**CHARLOTTE - MECKLENBURG
PLANNING COMMISSION**

SUBJECT: Administrative Approval for Petition No. 97-25 Seaboard Realty, Inc. Tax Parcel # 047-271-03

UNIVERSITY PLACE PARCEL X FOR SEABOARD REALTY, INC.

TECHNICAL DATA SHEET FOR PUBLIC HEARING PETITION NO. 97-25

Project Number: L.A. No. 87472.10
Sheet: C-2
DWG NAME: 8747210D.098

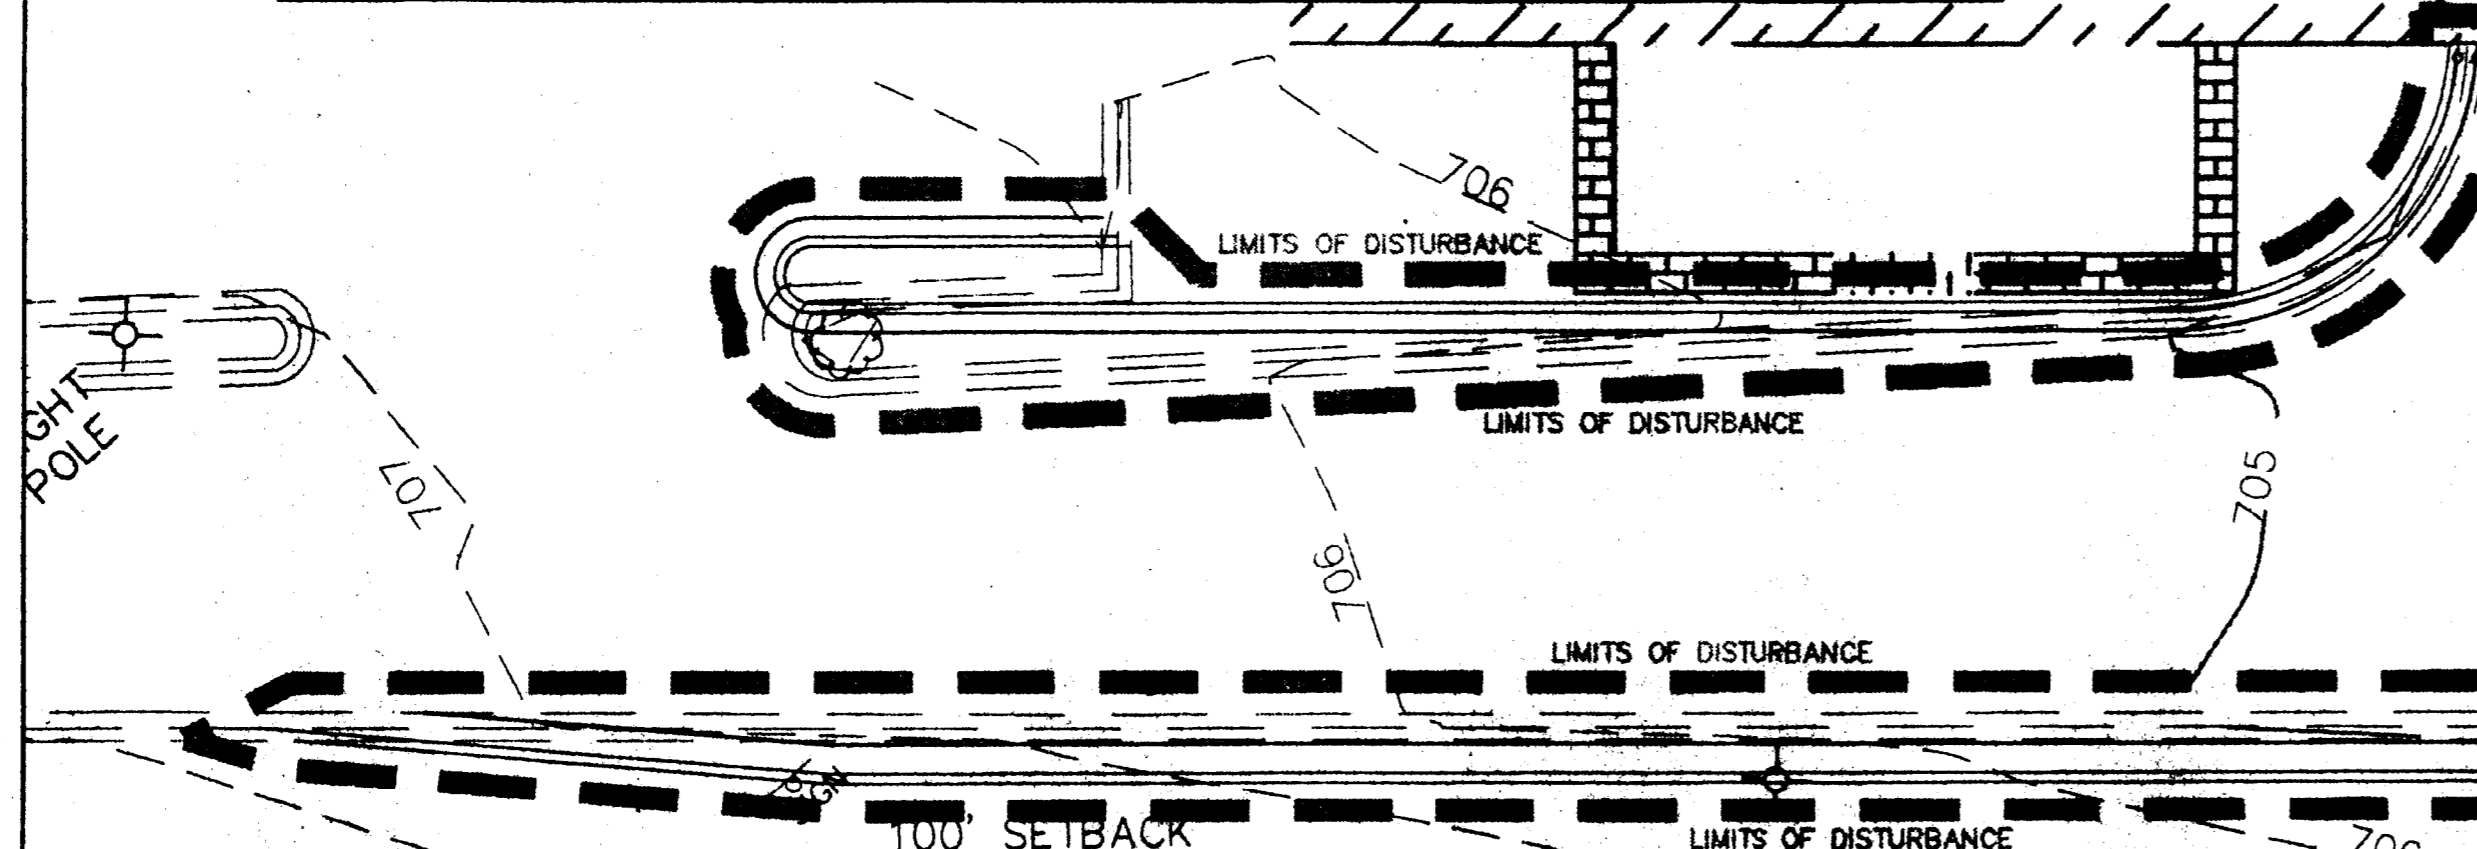
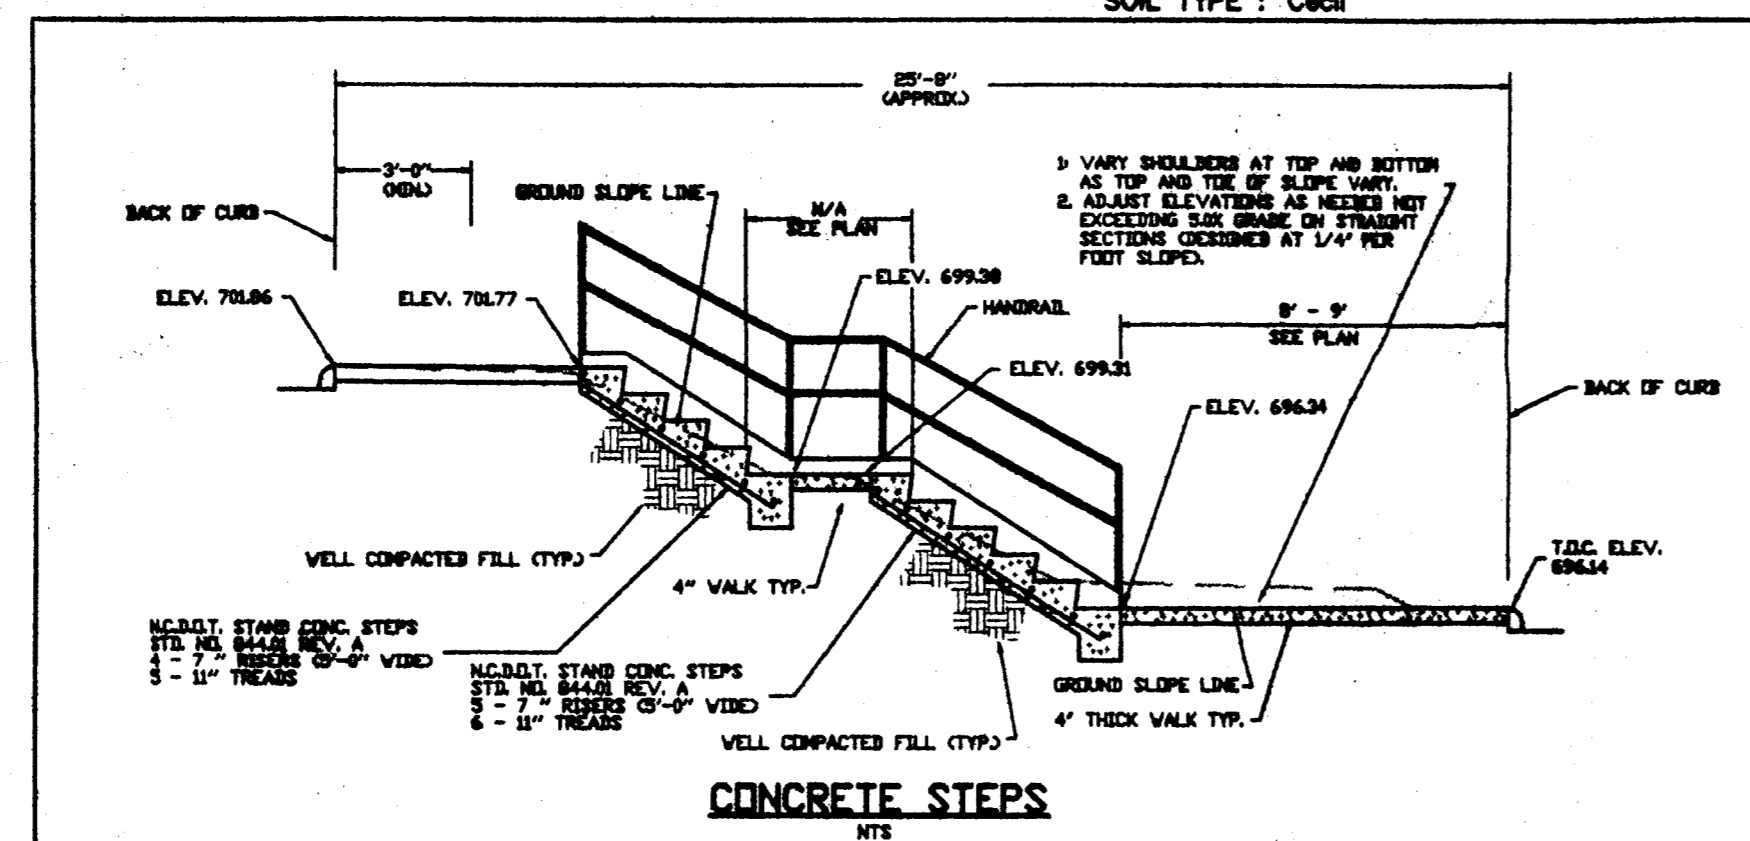
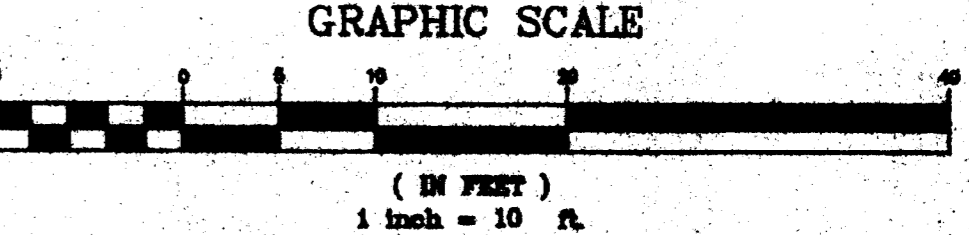
DESCRIPTION OF CHANGES

- ▲ ADDITION OF WALL, RELOCATION OF STAIRS, ADD 4 PARKING SPACES
- ▲ REARRANGMENT OF PARKING SPACES AT BOTTOM OF WALL

NO.	DESCRIPTION	DATE
1	AS SHOWN	06-03-97
2	ADD 4 PARKING SPACES	06-23-97

LANDSCAPE PLAN

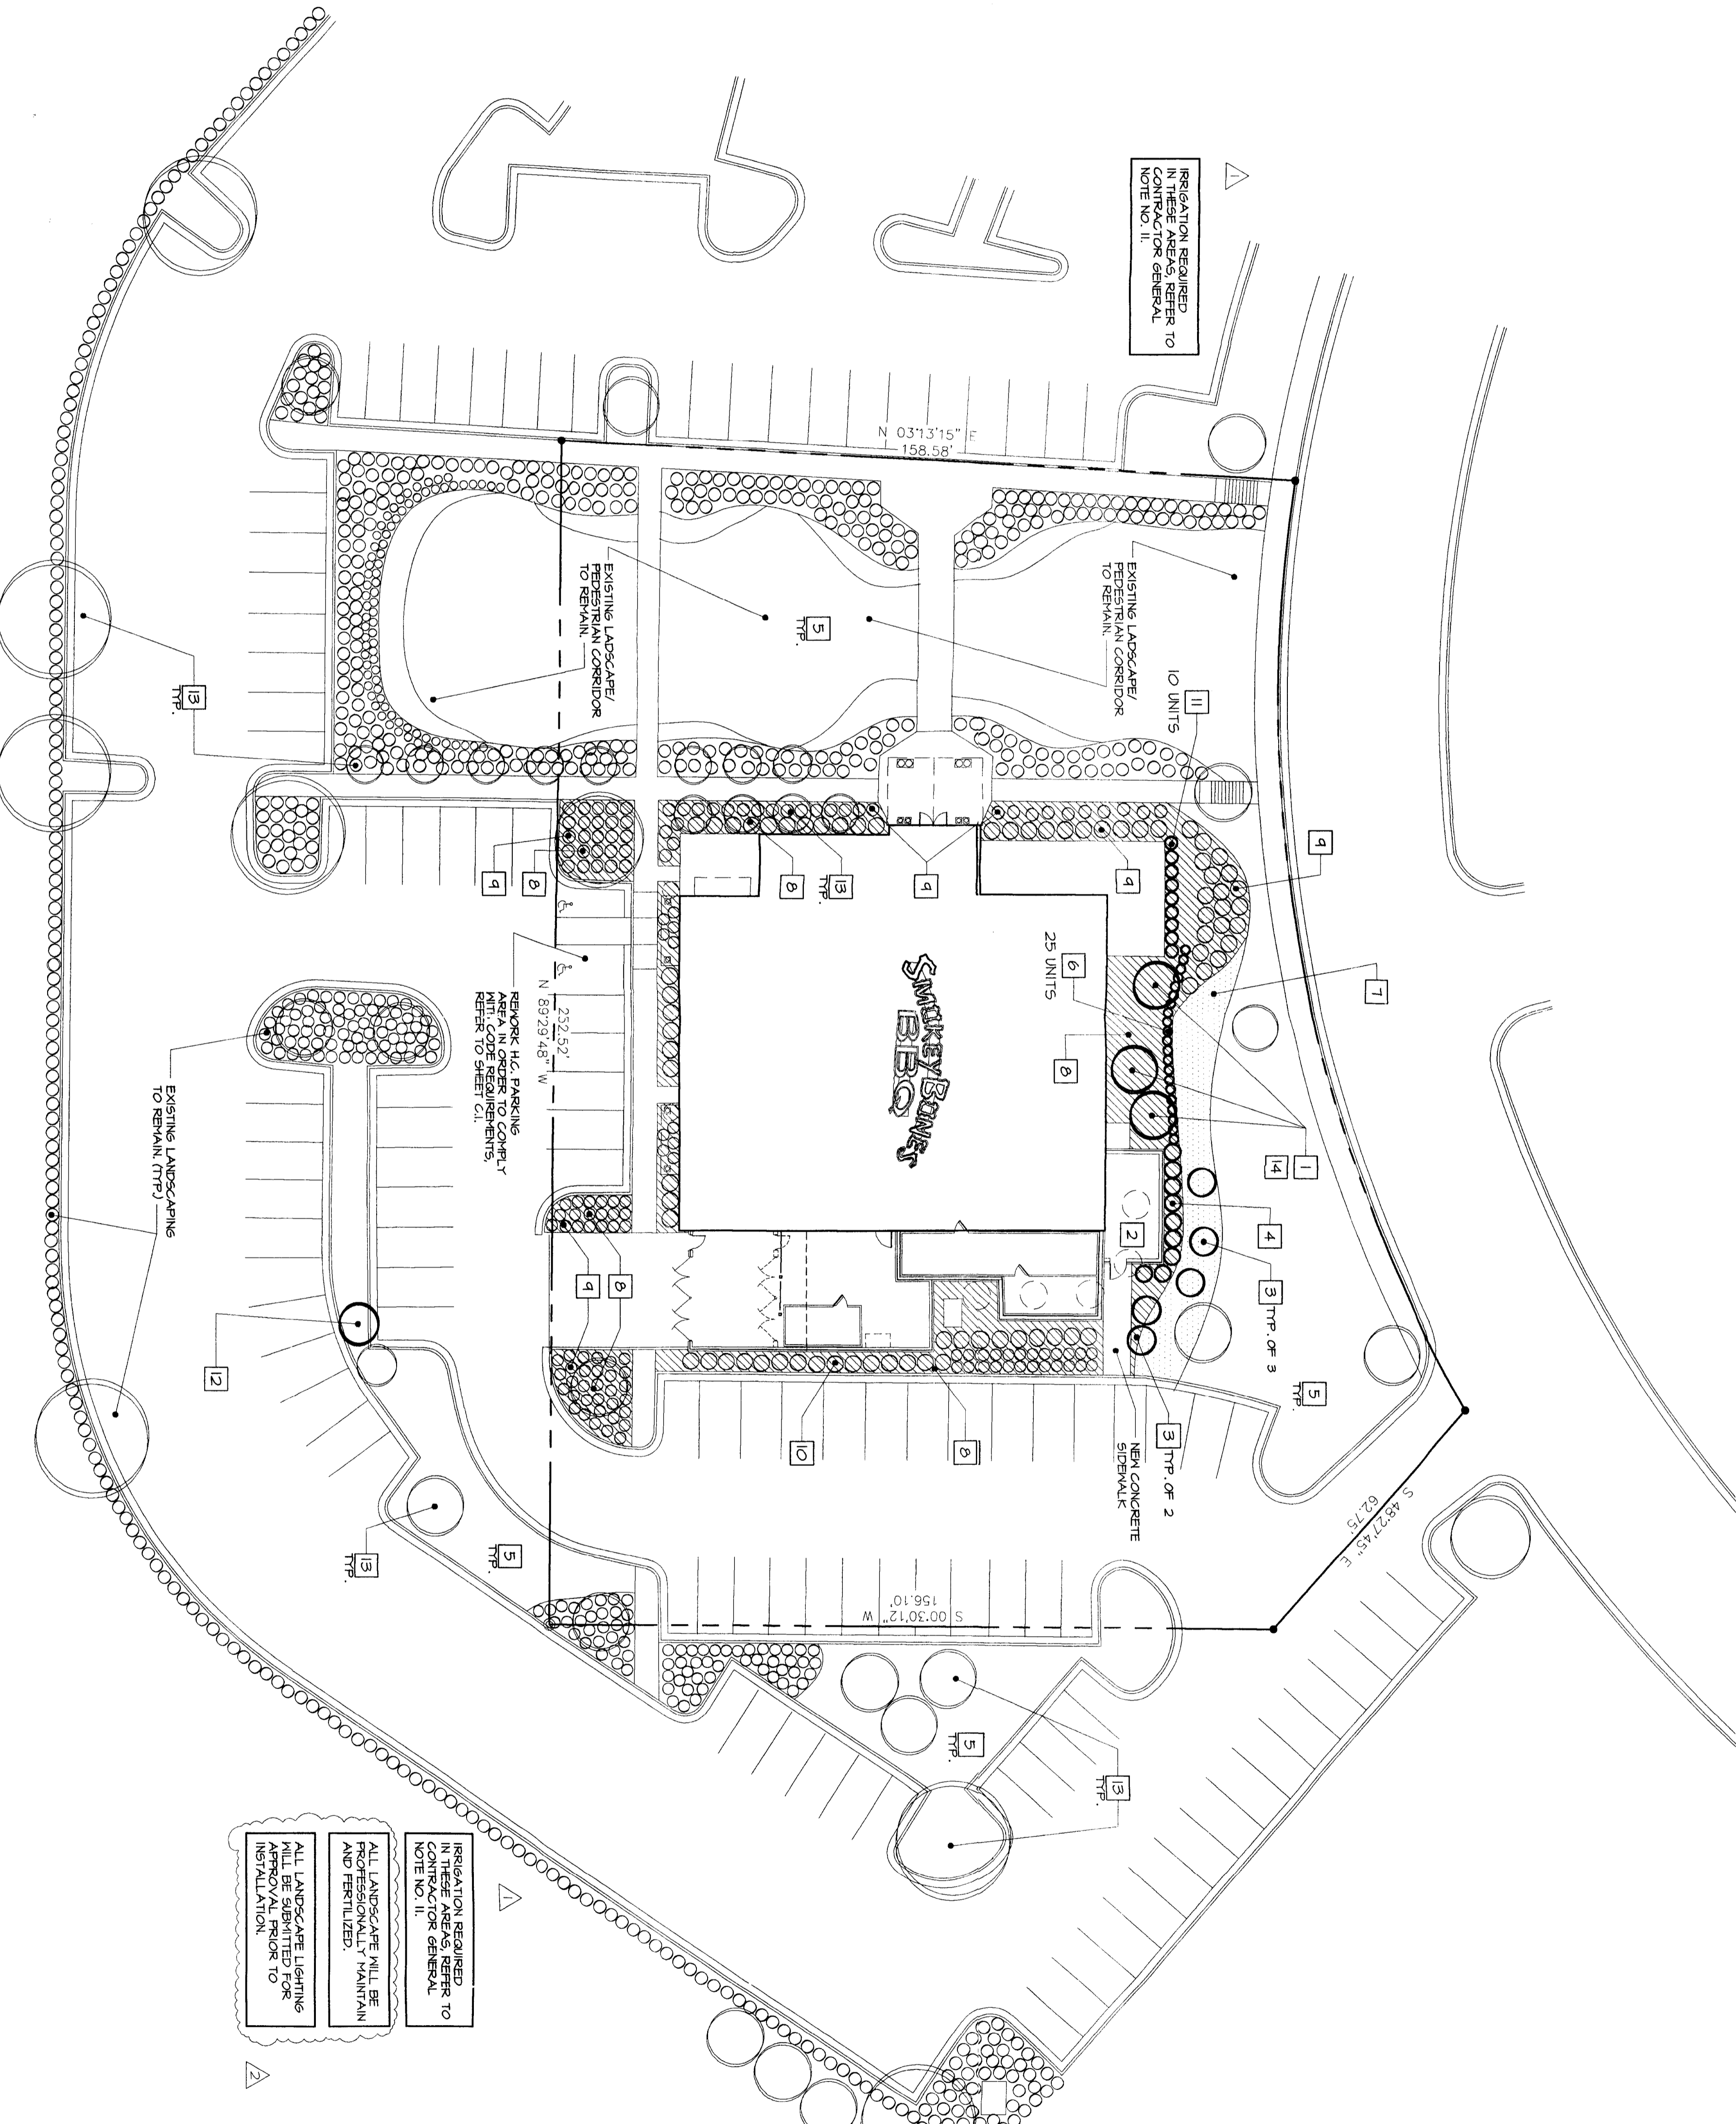
Attached are specific plans for the upfit of the restaurant formerly known as Houlihan's. The plan indicates, among other things, specific colors of stucco finish and log columns, the type of mulch to be used and specifies that the grounds/landscaping will be professionally maintained, shows the location for expansion for a smoker(s) and indicates screening for the expansion. Please use these plans when evaluating requests for building permits and certificates of occupancy.

NEW CUSTOM AWNING

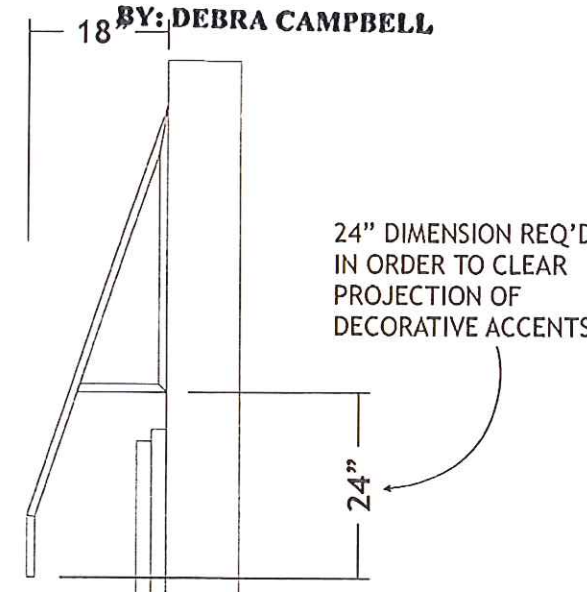
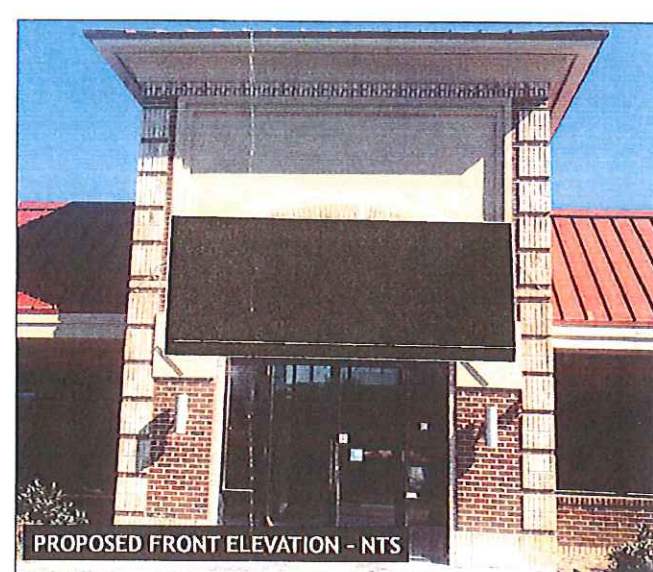
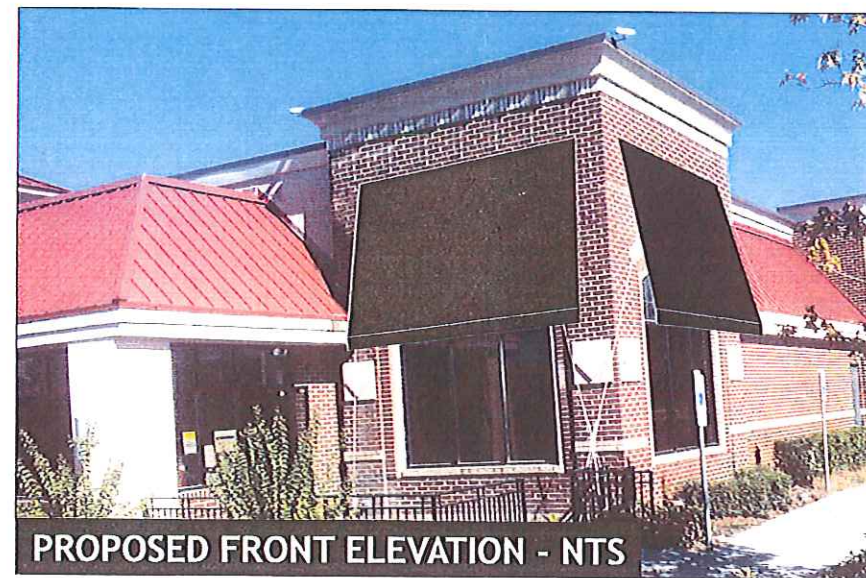
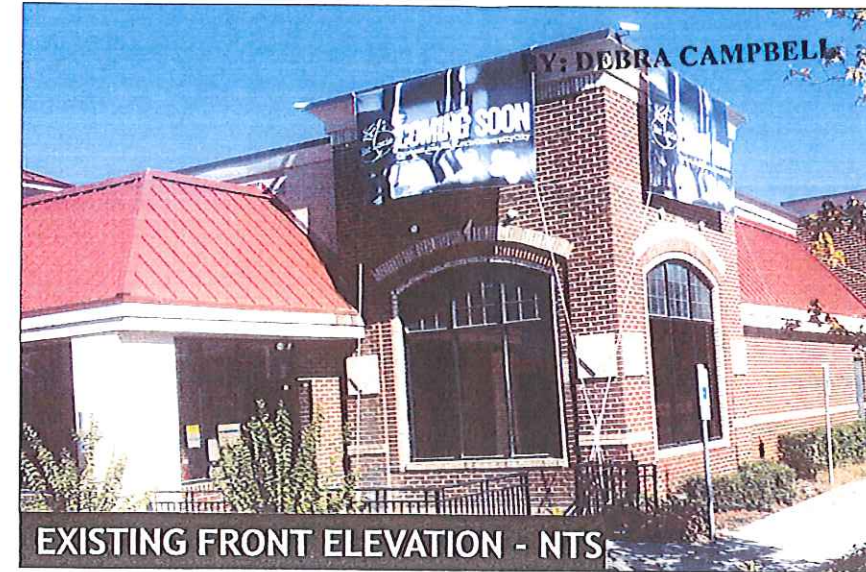
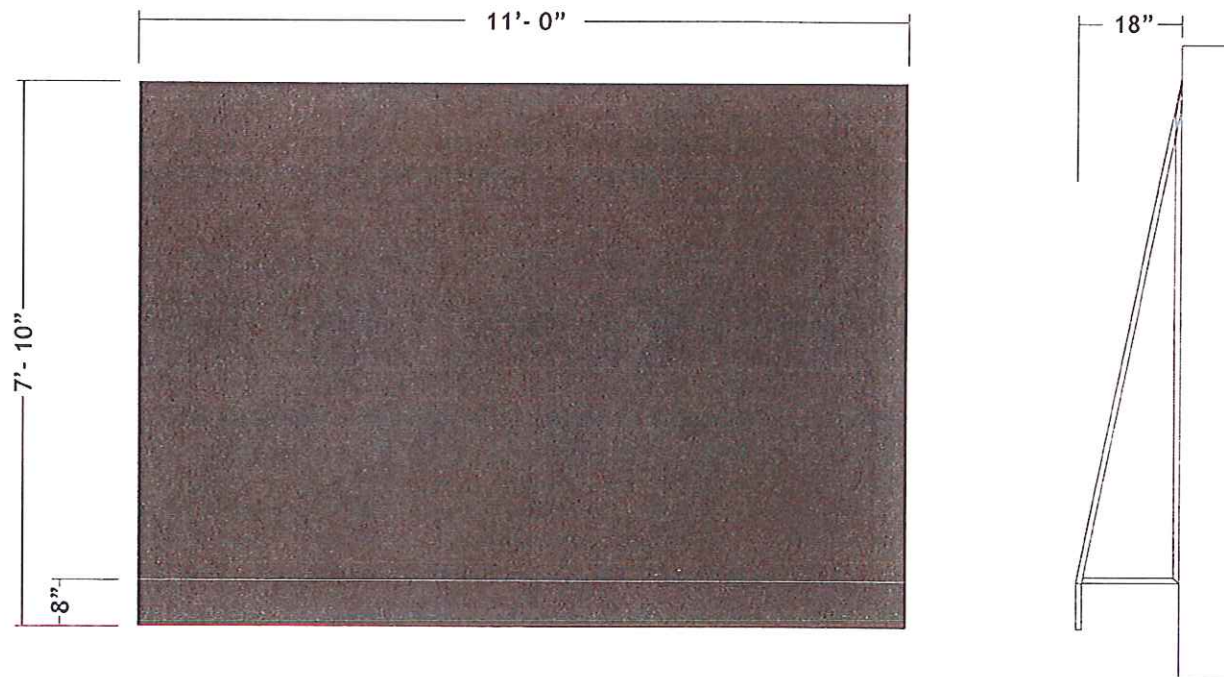
Attached is the elevations of the proposed awnings for an existing restaurant/and or nightclub. Since these changes do not alter the intent of the development and meet the requirements of the conditional site plan. Please use these plans when evaluating requests for building permits and certificates of occupancy.
